Metro East Bicycle User Group (MeBUG) Response

to the Parks Victoria 2022 Concept Design Report and Park Layout Plan

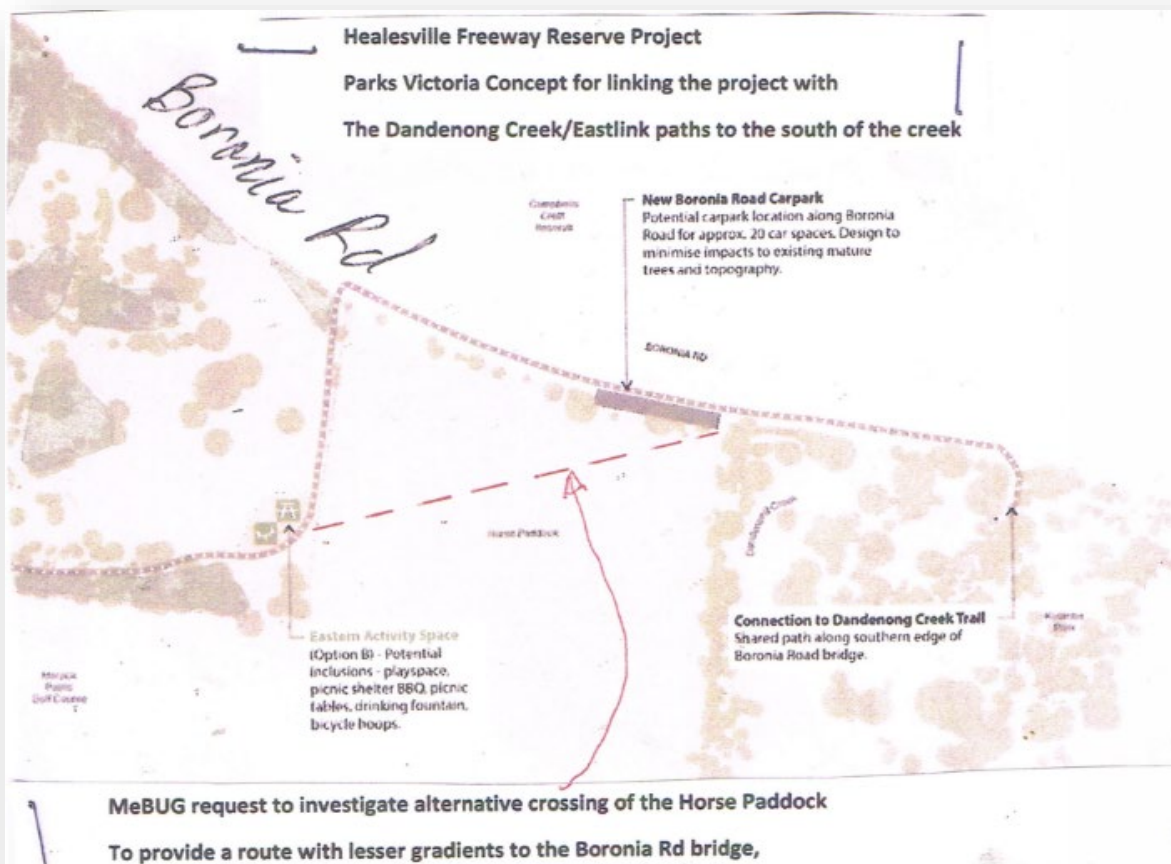
We ask Parks Victoria to investigate the possibility of a more direct exit/entry via Crown land 122H, named “Horse Paddock” on the draft map.

- remove some of the steep gradient problem, including the gradient in Boronia Rd.
- save on the cost of a path on Boronia Rd.
- enable the path to be located more safely to the west of the new car park
- align an entry/exit to the park with the proposed new car park.
- make it easier for disability access from the car park.
- Provide a more attractive, expansive view on entering the park

- Sightlines for cyclists and pedestrians are limited along the Dandenong Creek Trail just south of Boronia Road. The junction needs to have this consideration in mind.
- Vehicles in the current and new car parks should not interface with passing cyclists or pedestrians.
- Cyclists entering Koomba Park from Boronia Road should be protected from cars in the car park by a short length of Shared Path between the new path in Boronia Rd and the existing gravel path.
